From: Helgardt Slabbert <helgardt@valumax.co.za>
Sent: Friday, September 11, 2020 2:39 PM
To: Vanessa Stippel
Cc: De Wet Botha
Subject: RE: 21637 | Notification of Public Review of EIA Report and WULA Technical Report | Proposed Development of Riverside View Extension 84, City of Johannesburg, Gauteng (GAUT 002/17-18/E2040)

ADDENDUM 1 | RESPONSE TO CITY OF JOHANNESBURG IMPACT ASSESSMENT AND COMPLIANCE MONITORING COMMENTS DATED 12 OCTOBER 2020

ADDENDUM 2 | RESPONSE TO GDARD'S COMMENTS DATED 26 OCTOBER 2020

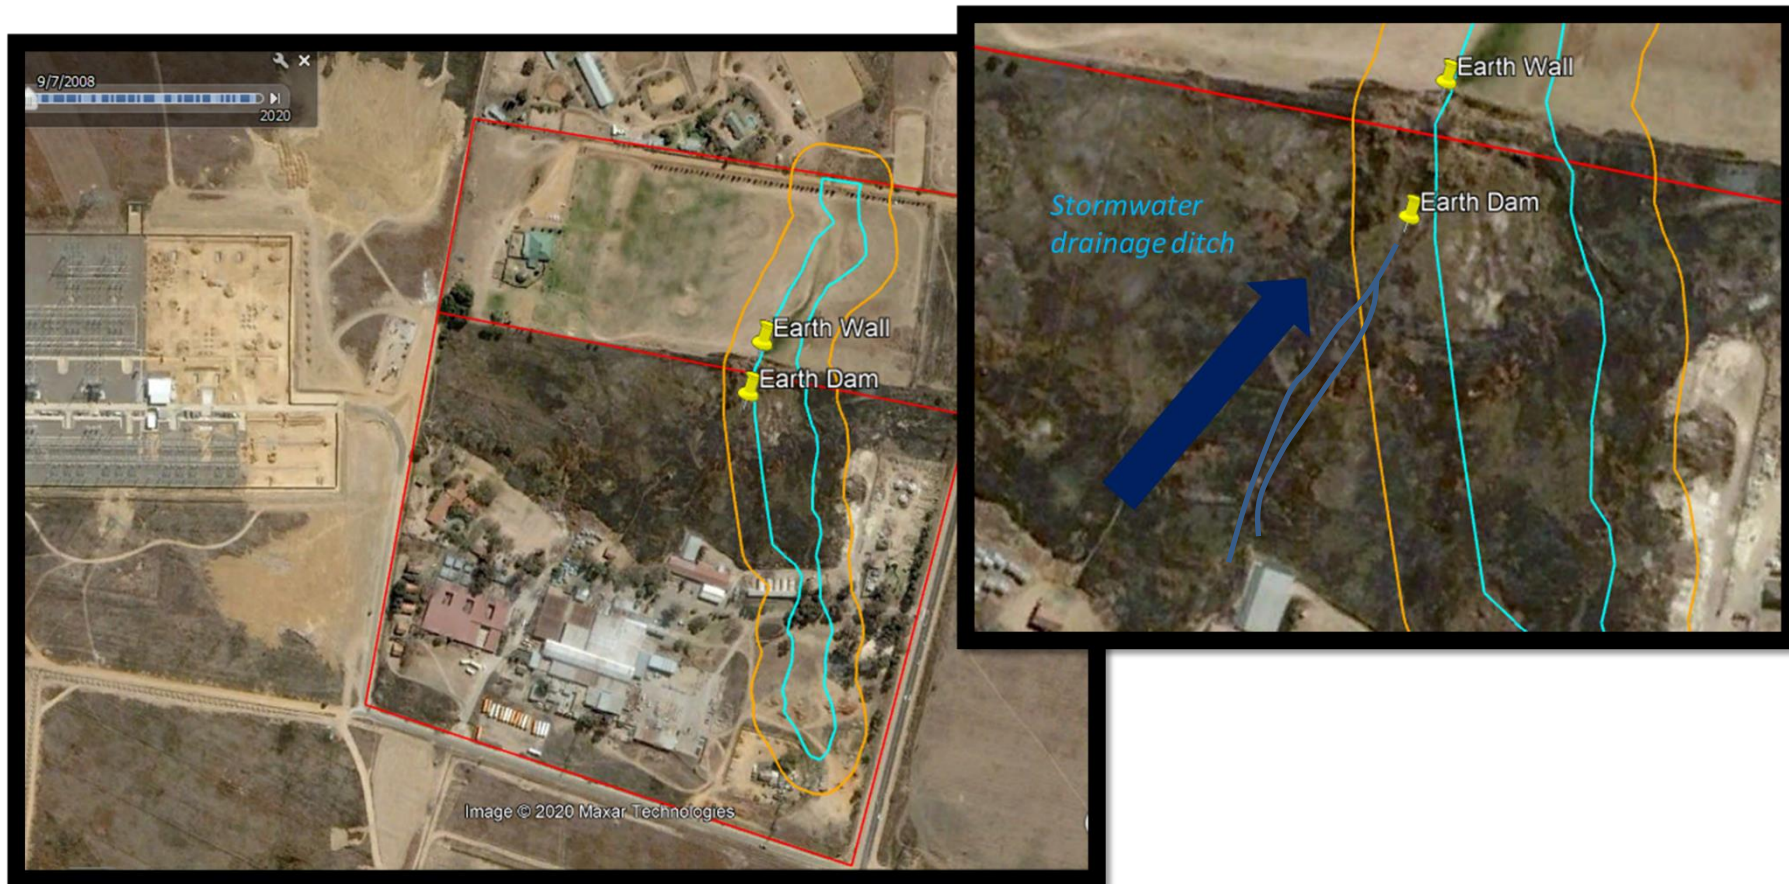
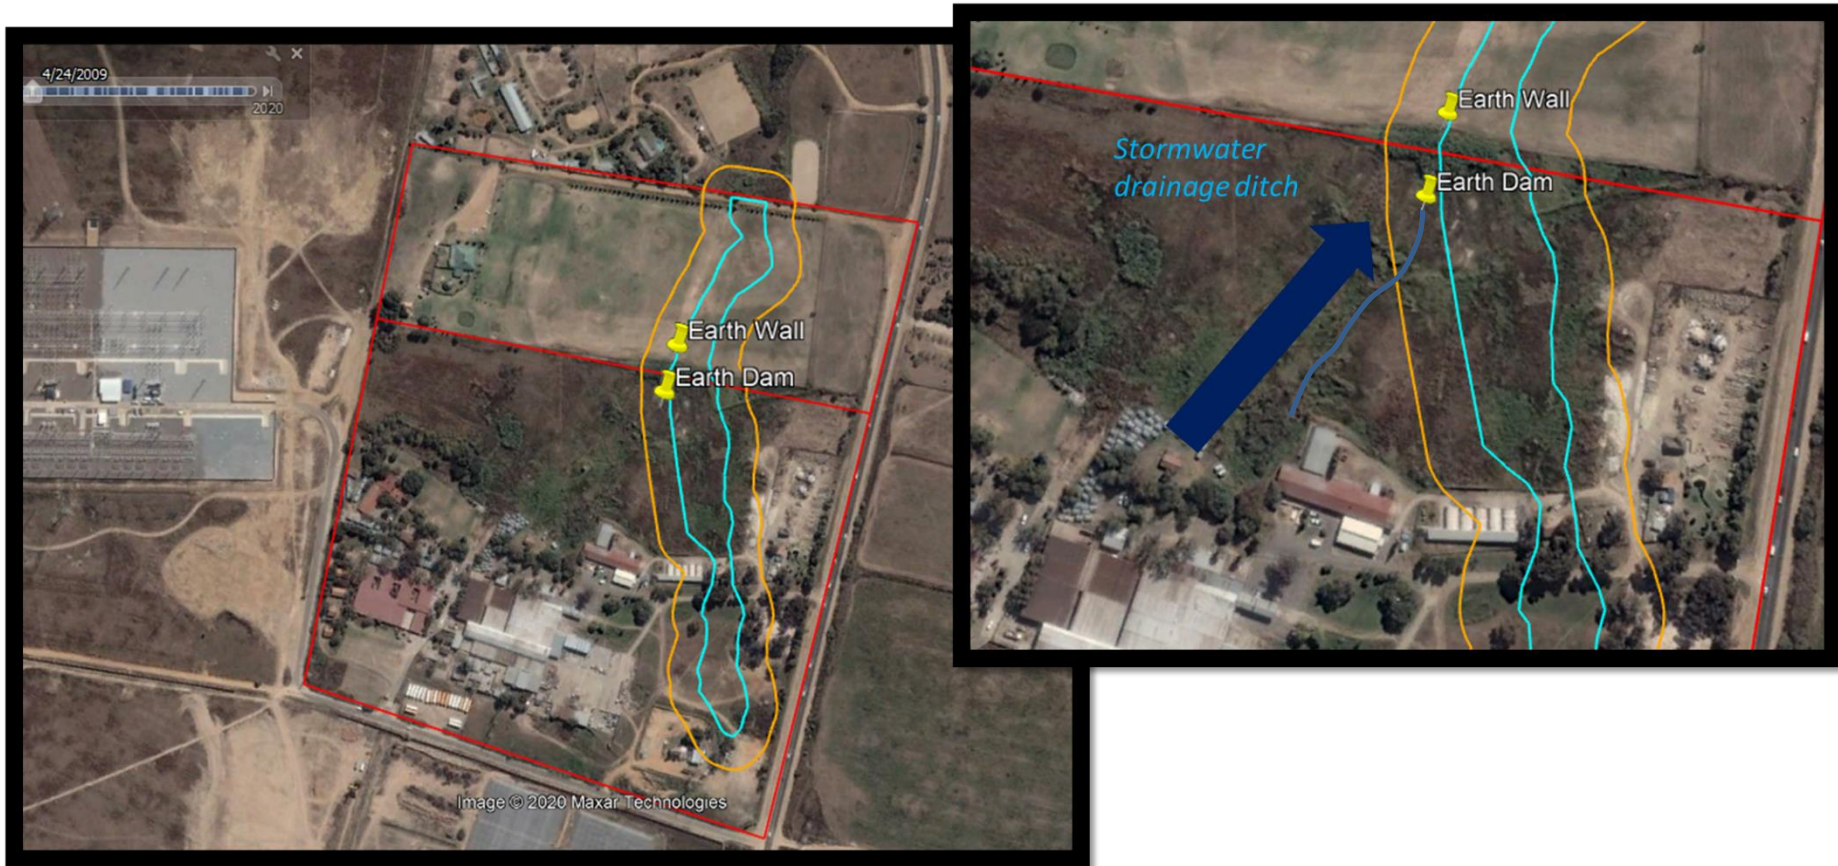
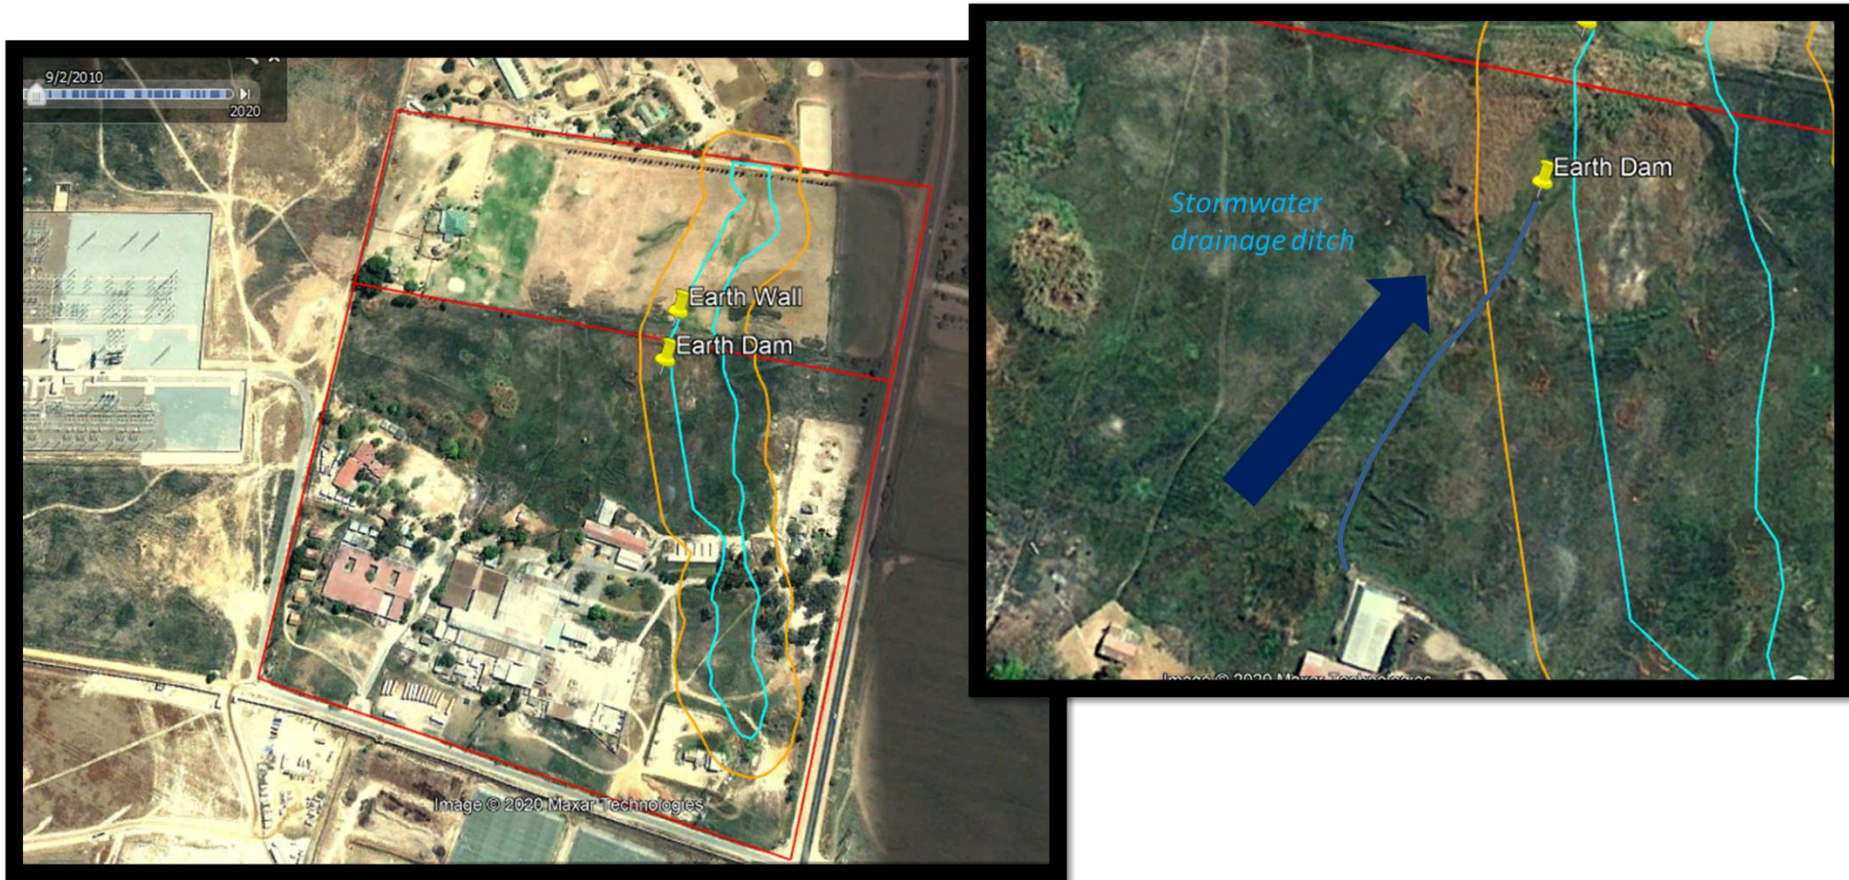
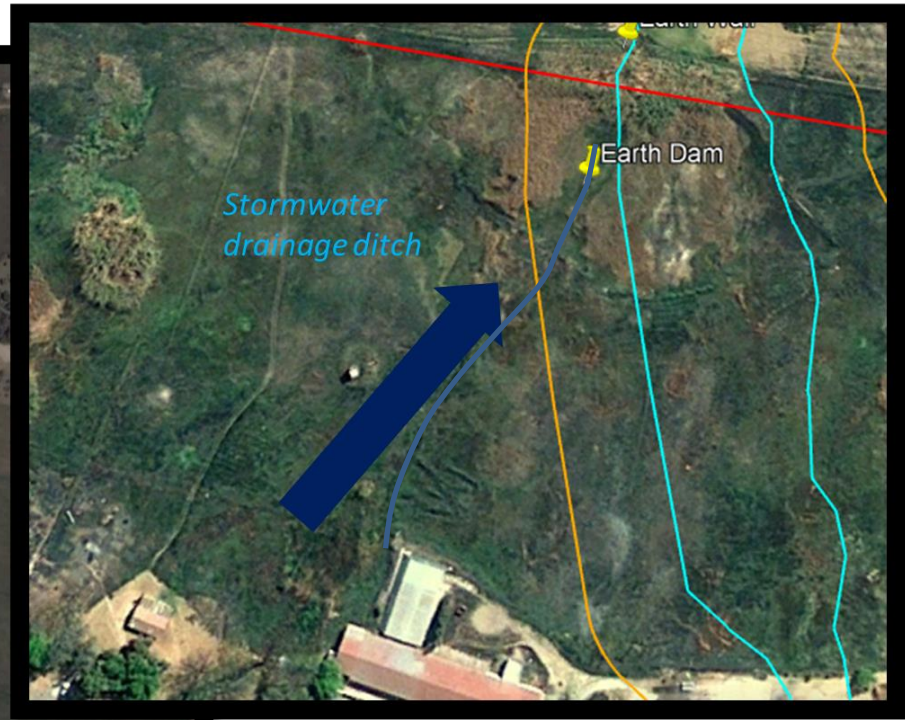
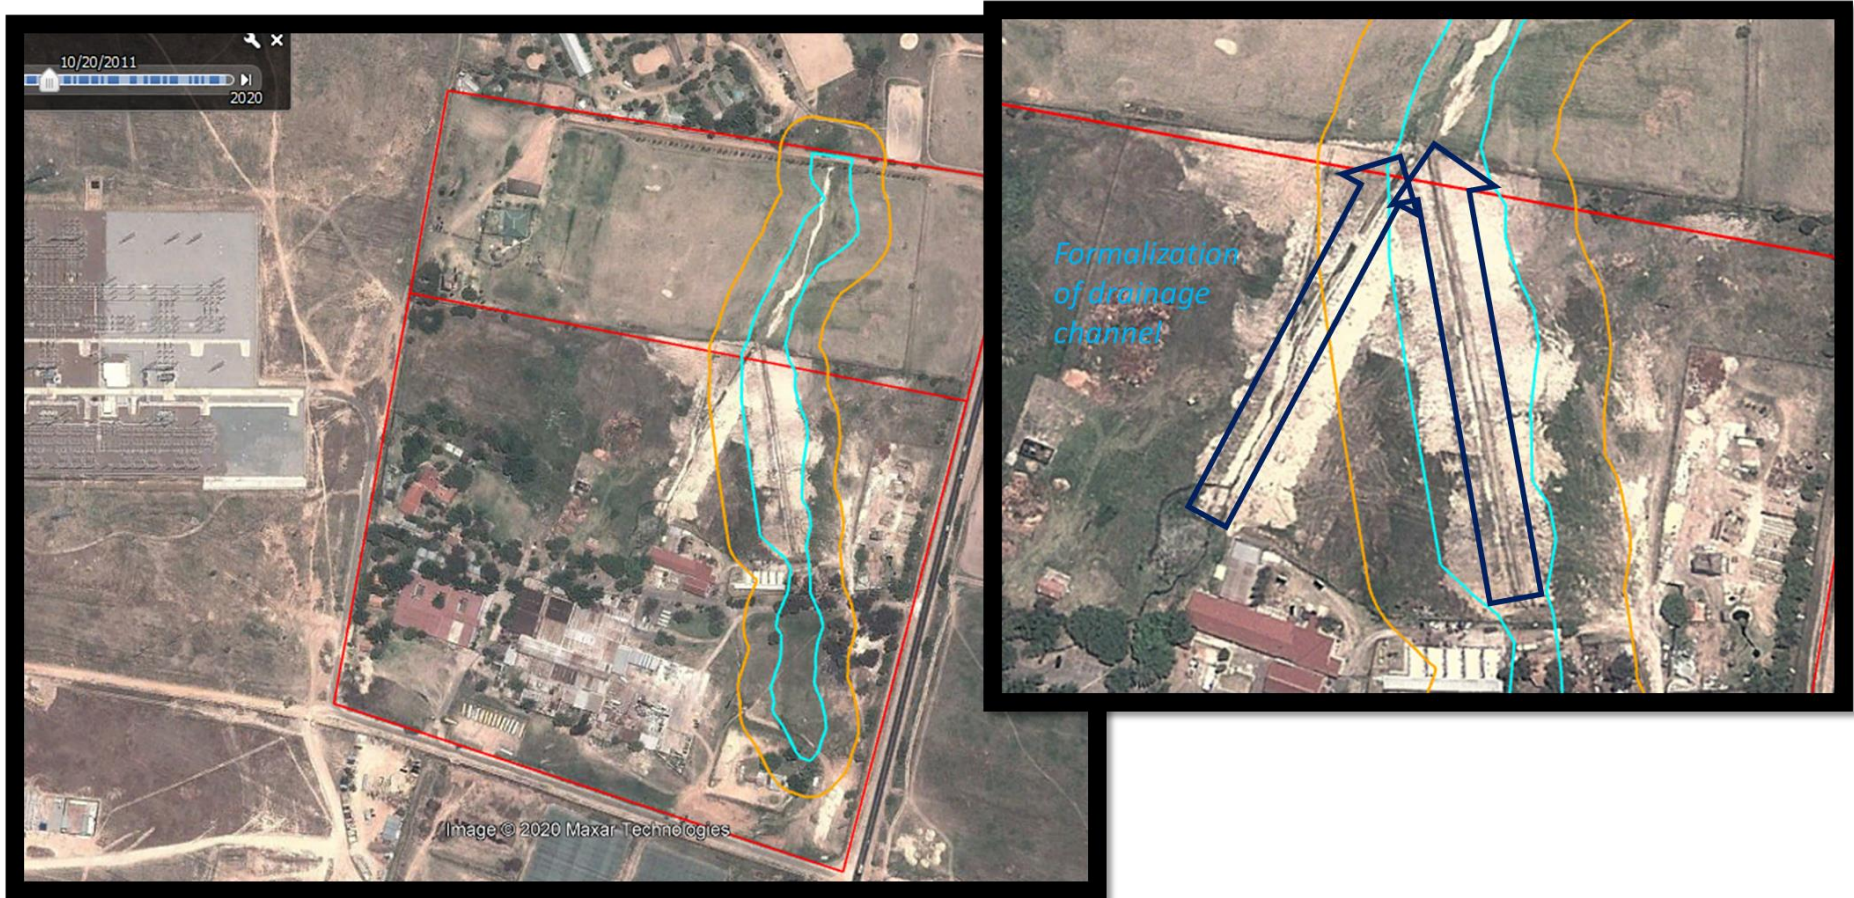
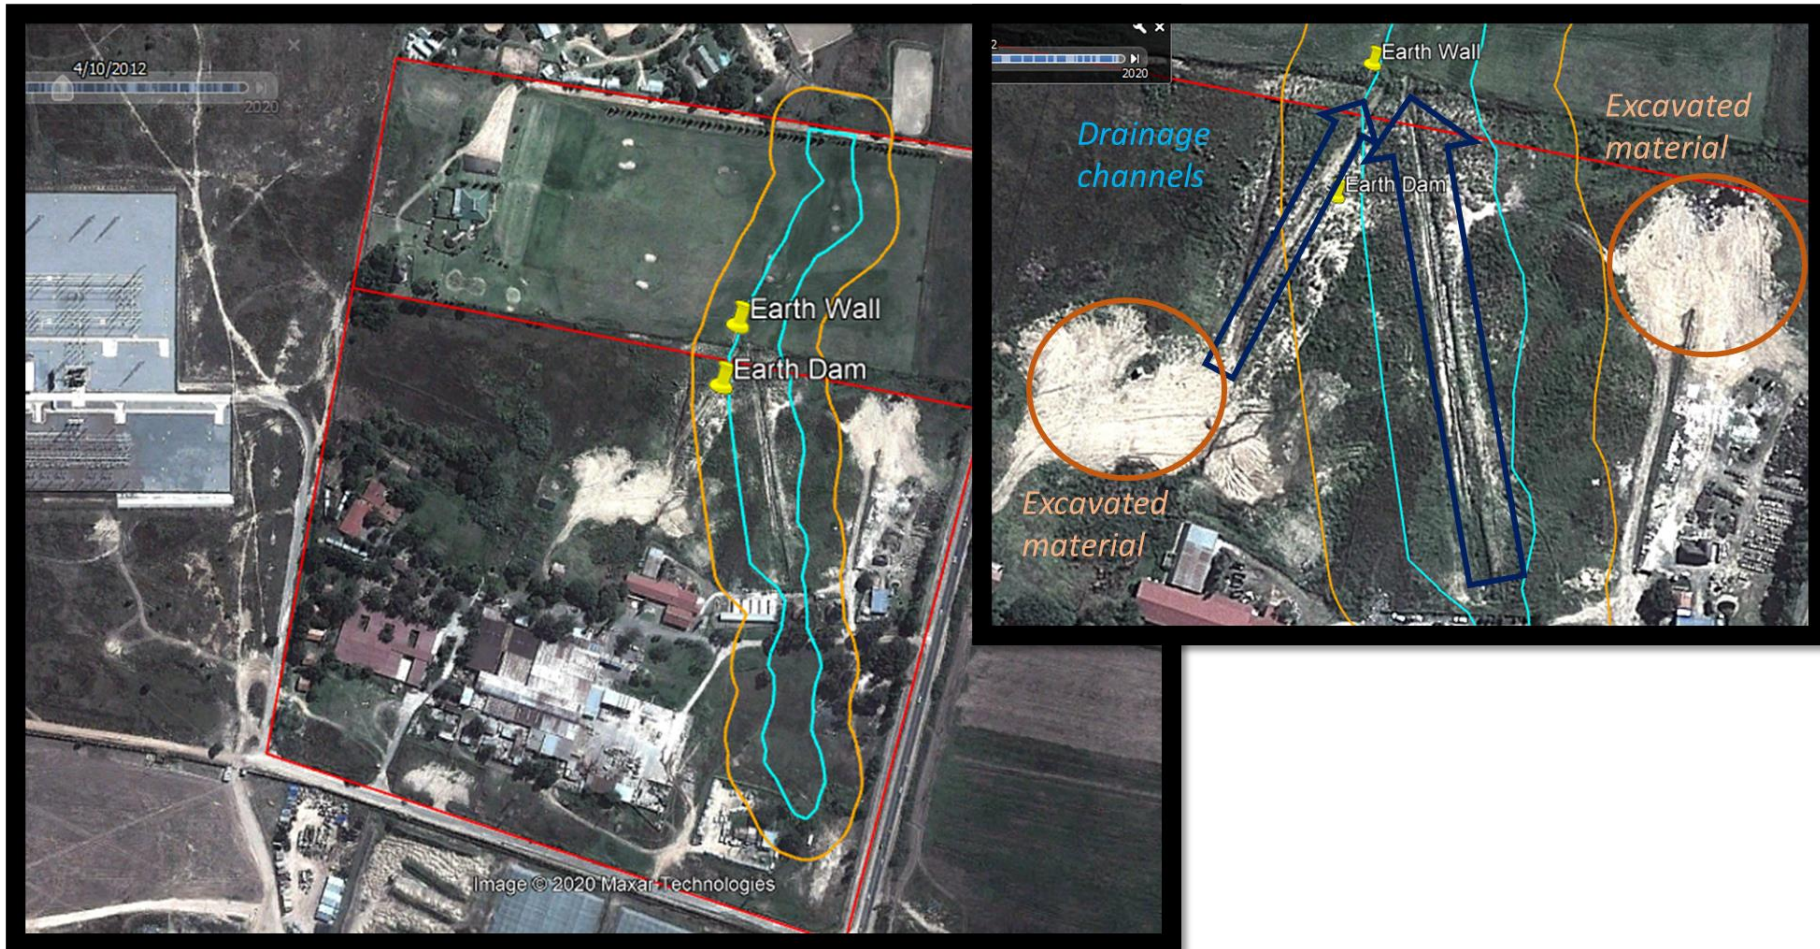
- *Further, the geotechnical report by the engineering geologist confirms the presence of seasonal perched groundwater tables and/or saturated soil profiles, not confined to the riparian zone only. Figure 9-11 indicates extensive areas designated as Zone III which are noted to be wet and marshy. This would be consistent with the National Wetlands Map 5 (Van Deventer et al 2019) and the City's own indicative wetland layers. The historic vegetation maps appear to show these areas in existence. Furthermore, extensive seep wetlands associated with valley bottom wetlands is a common feature of the Halfway House Granites.*

Google Earth imagery has therefore been utilized to provide a summary of the historic use of the site and how this has affected surface water. The aim of this is to provide a timeline and place the findings of the Geotechnical Studies into context as well as the findings of the Baseline Biodiversity Baseline and Impact Assessment.

Please refer to **Figure 2, 3 and 4** below.

*“The general slope of the area is to the north with locally gradients towards the east and west due to a shallow stream channel running from south to north through the eastern part of the holding. **The drainage feature has been modified due to stormwater trenches, runoff from large concrete paved areas and septic tank drainage fields. A stormwater drainage ditch runs through the central part of the holding into an earth dam on the central northern boundary with the golf driving range. The shallow stream and dam areas will be prone to marshy conditions. Locally levelled platforms were created via cut to fill to accommodate the large paved areas and buildings.**”*

*The northern parts of the site have been left fairly undisturbed apart from the **shallow dam in this area**. The school on the western part comprises of classrooms, sports fields and open veldt area to the north. The Lulamisa Eskom Substation is situated directly adjacent to the west of the property.”*
